8A Miscellaneous Electrical Systems

The information in this appendix of the reference ABWR DCD, including all Subsections and figures, is incorporated by reference with the following departures and supplements.

Figure 8A-1 Site Plan (Grounding)

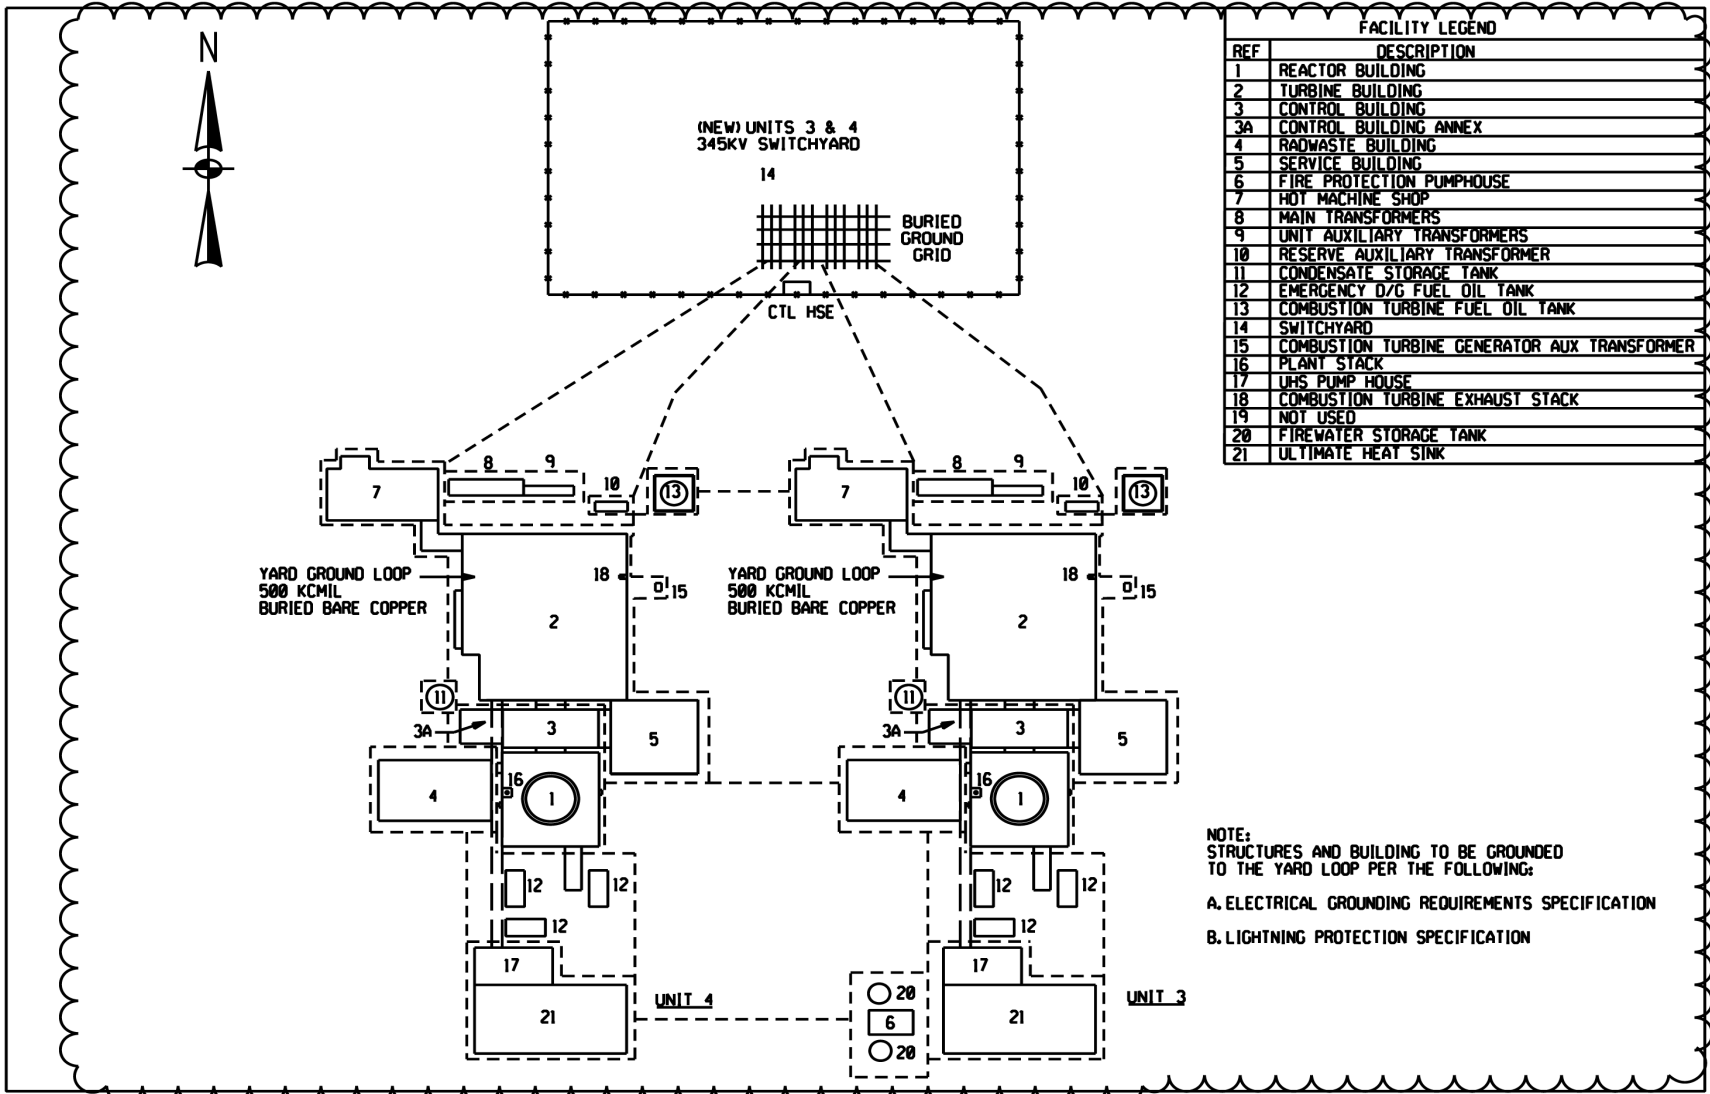
STP DEP 1.1-2 (Figure 8A-1)

STP DEP 1.1-2

- (3) A plant grounding grid shared between STP Units 3 & 4
